Private Fuel Storage, LLC

**RESPONSES TO SECOND ROUND EIS
REQUEST FOR ADDITIONAL INFORMATION
DOCKET NO. 72-22/TAC NO. L22462
PRIVATE FUEL STORAGE FACILITY
PRIVATE FUEL STORAGE L.L.C.**

References: 1) NRC Letter, Flanders to Parkyn, Request for Additional Information for the Environmental Impact Statement, dated August 19, 1999

Figure 11 – ITP, looking northwest from I-80, is located left of center adjacent to the mainline railroad (line of poles at the base of the mountainous background).

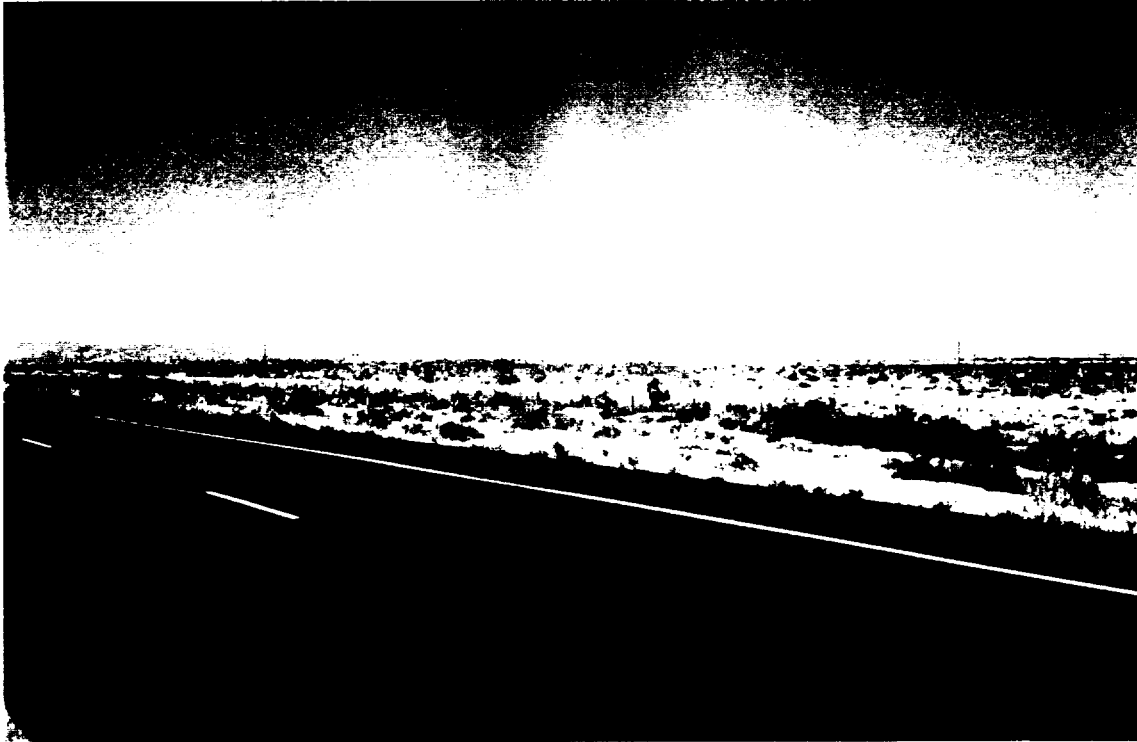
The rail equipment parked on the sidings, including loaded casks (or cask) awaiting transfer to the heavy haul trailer and the railroad equipment awaiting pickup by Union Pacific, would be in full view of the traveling public on east and westbound I-80 (Figure 12). This view, at the closest point, is approximately 550 feet. It is anticipated that for the maximum train size of 3 loaded cask cars, it would take approximately 28 work hours to complete the transfer of the last cask to the heavy haul trailer for delivery to the PFSF. This is based on the use of a single heavy haul trailer; the second heavy haul vehicle and truck is an available spare. The more typical receipt of 2 cask car trains would require approximately 16 work hours to complete the transfer of the last cask to the heavy haul trailer for delivery to the PFSF. Since PFS will be capable of contacting the loaded single purpose train at all times and controls the number of casks per single purpose train, the arrival to the ITP would be known in advance to plan, coordinate and facilitate the transfer. Extended workdays will likely be used for those infrequent times a 3-cask train is processed through the ITP.

FIGURE 1 – Low, UT looking west. Railroad sidings will be at grade on the left to 27' below grade in the distance at the railroad mainline (center of photo).

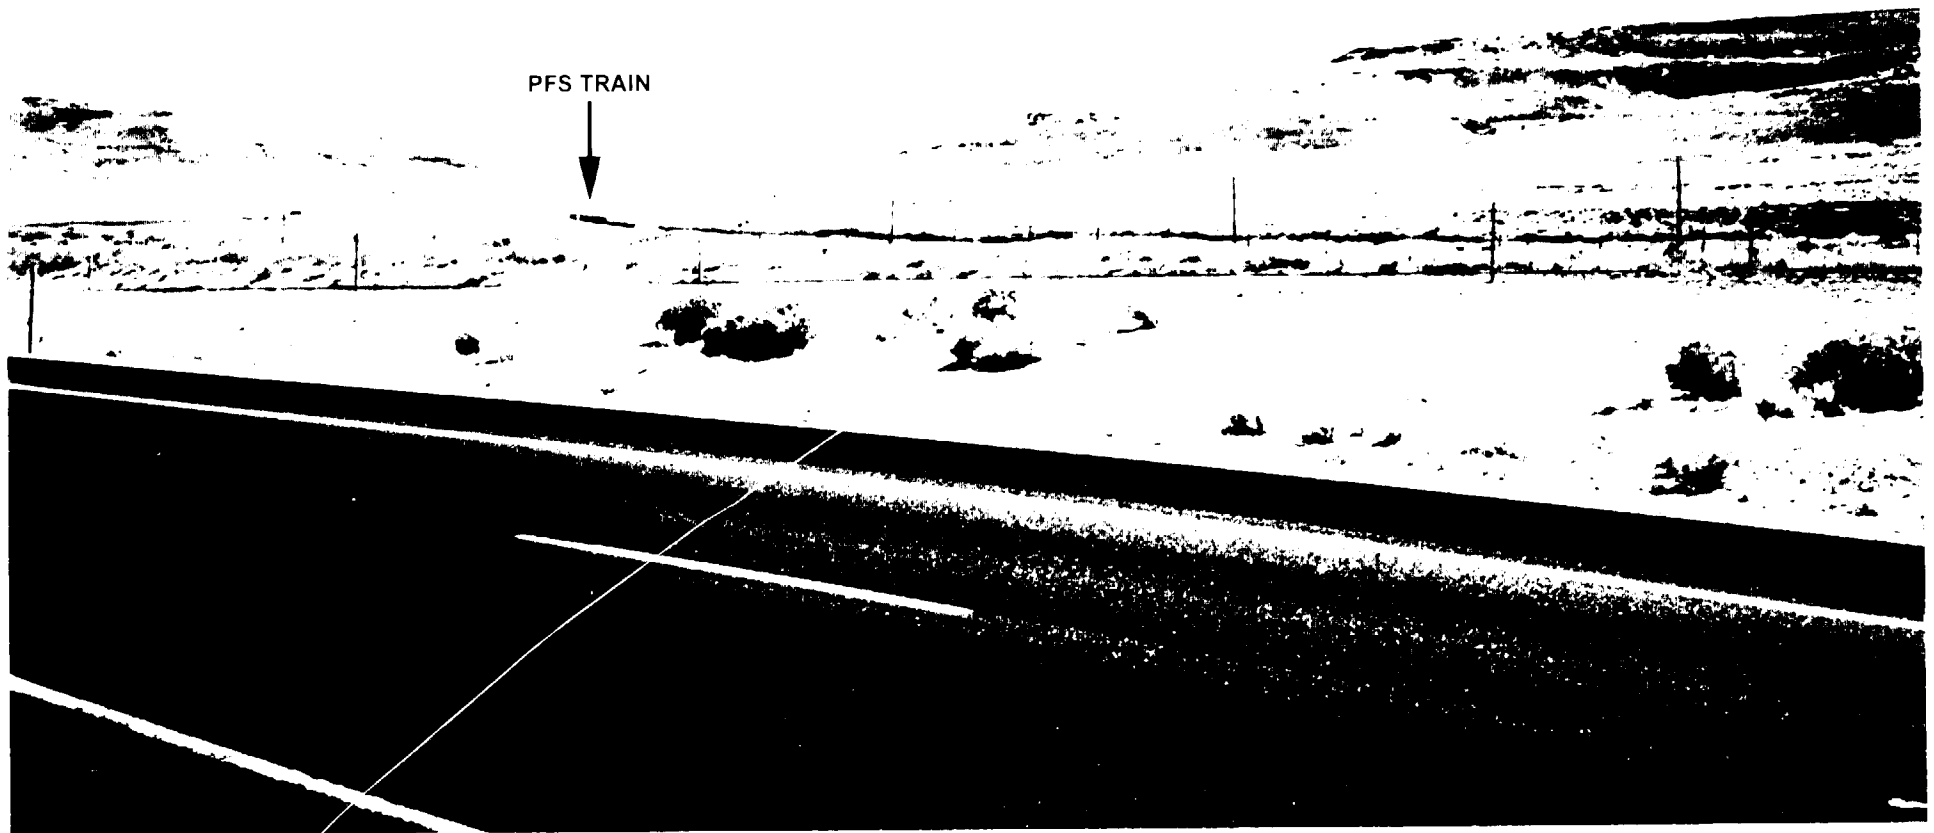
Westbound I-80 vehicular traffic, traveling at the posted speed limit of 75-mph, approaching the Low siding area, would have a limited opportunity for viewing a SNF train or empty cars that are stationary at the siding area (Figure 1). Since the siding area is substantially below grade (at grade to 27' deep), the stationary SNF train or parked empty cars would be hidden from view or partially visible due to the natural topography of the siding area (Figure 2). Eastbound I-80 traffic approaching the Low area would be visually blocked from seeing the siding area until after passing the highway overpass crossing I-80 at which point the siding area would be adjacent to or behind the viewing public (Figures 3 and 4). Again, the stationary SNF train or empty cars would be hidden or only partially visible due to the topography of the area and the fact that the siding area will be substantially below grade. The view of any of the rail equipment on the sidings would be limited to the upper portion of a car or locomotive.

Figure 8 – Morton Salt Plant approximately 8 miles east of Timpie, UT looking northwest from I-80.

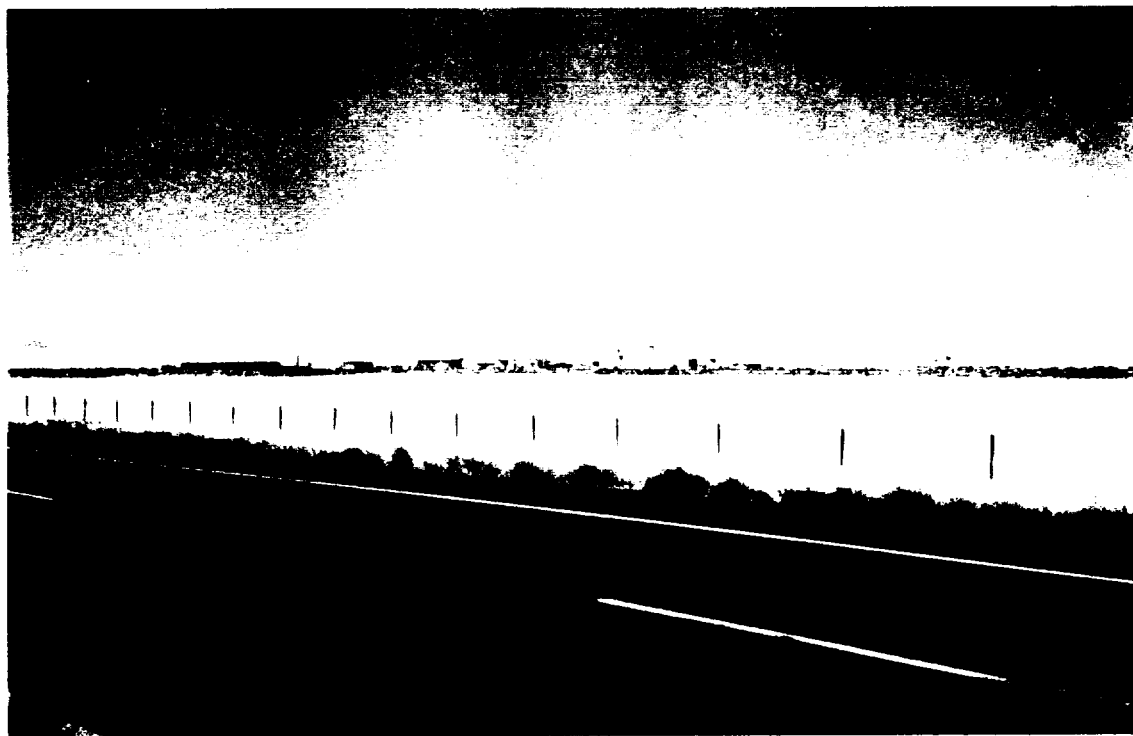
In comparison, the Low siding area offers less of a viewing vista than other existing industrial areas along I-80 including the two salt plants (Morton and Cargil, Figures 8 and 9) and the existing rail sidings at Timpie, Utah (Figure 10).
